SECTION 4.55 MODIFICATION

Modification to DA/538/2019

607 Canterbury Road, Belmore

Document Type: Section 4.55 Modification Report

Drawing Title STORMWATER CONCEPT PLAN				
Scale 1:100	A1	Project No. 22120	Dwg. No. 101	Issue A

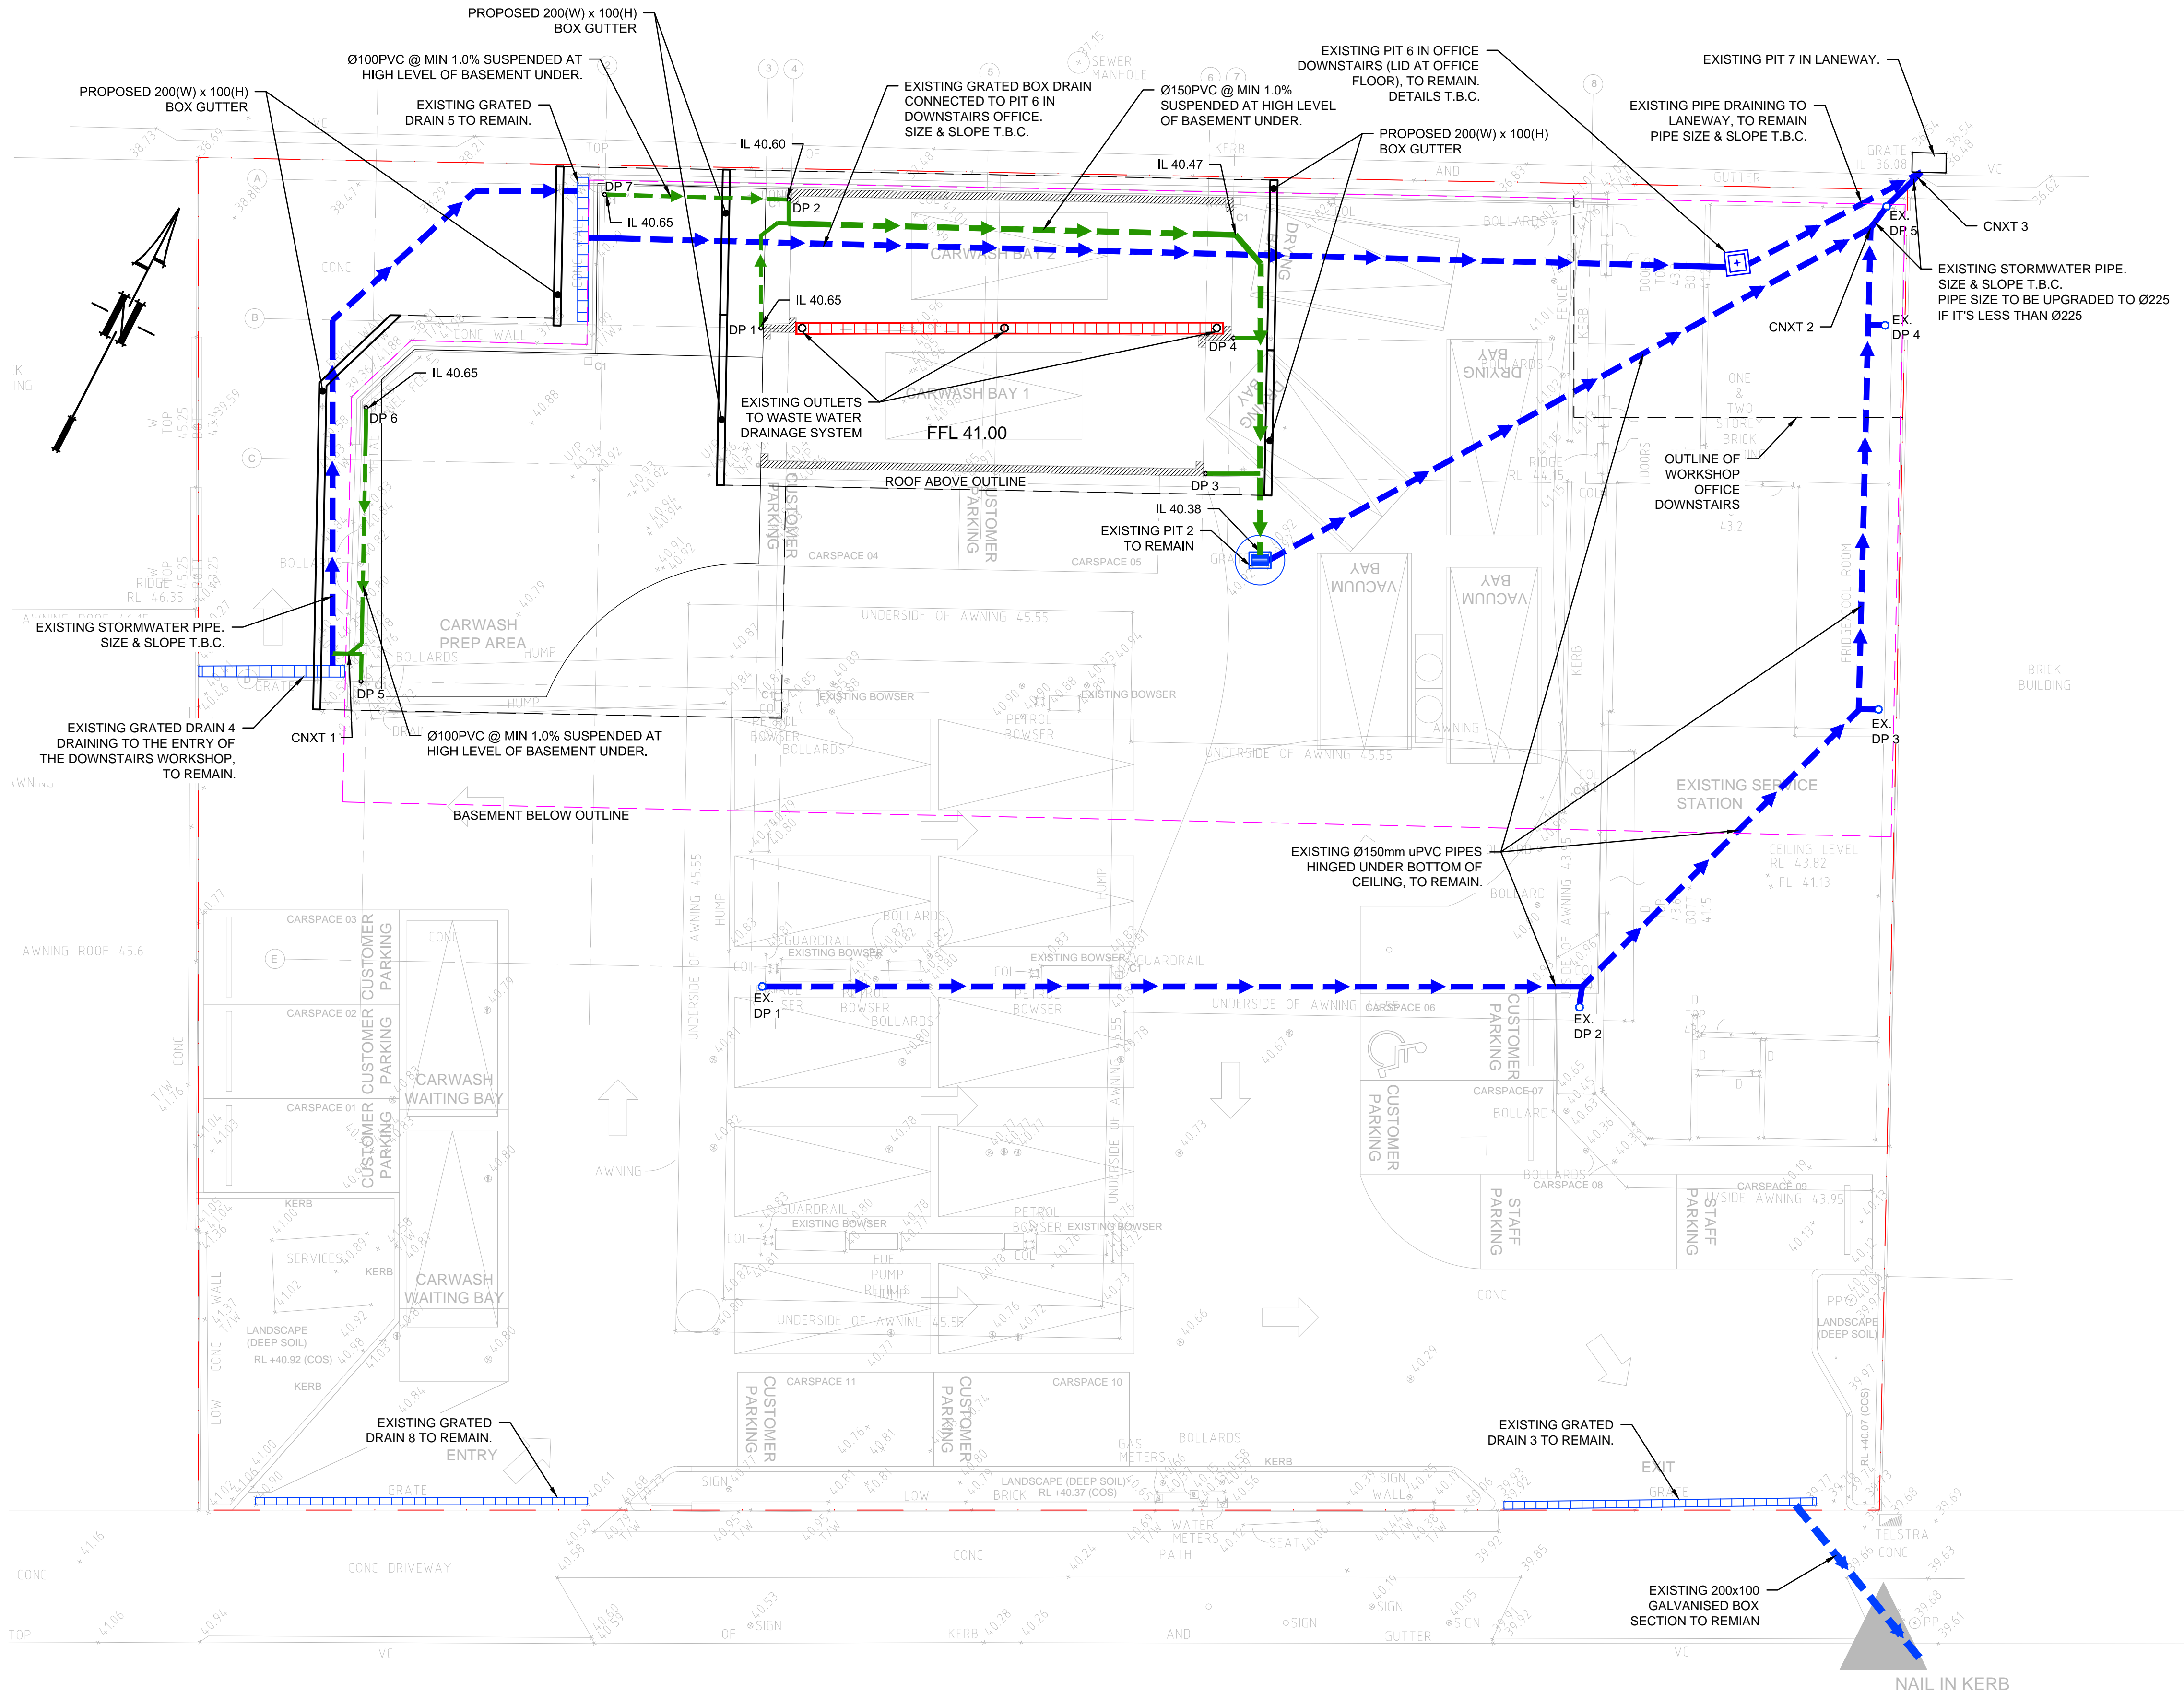
The Construction Certificate stormwater design was defective and a revised stormwater design that adopts the correct area calculations relating to the new structure is required to be adopted. The amendment stormwater concept is in Appendix 3.
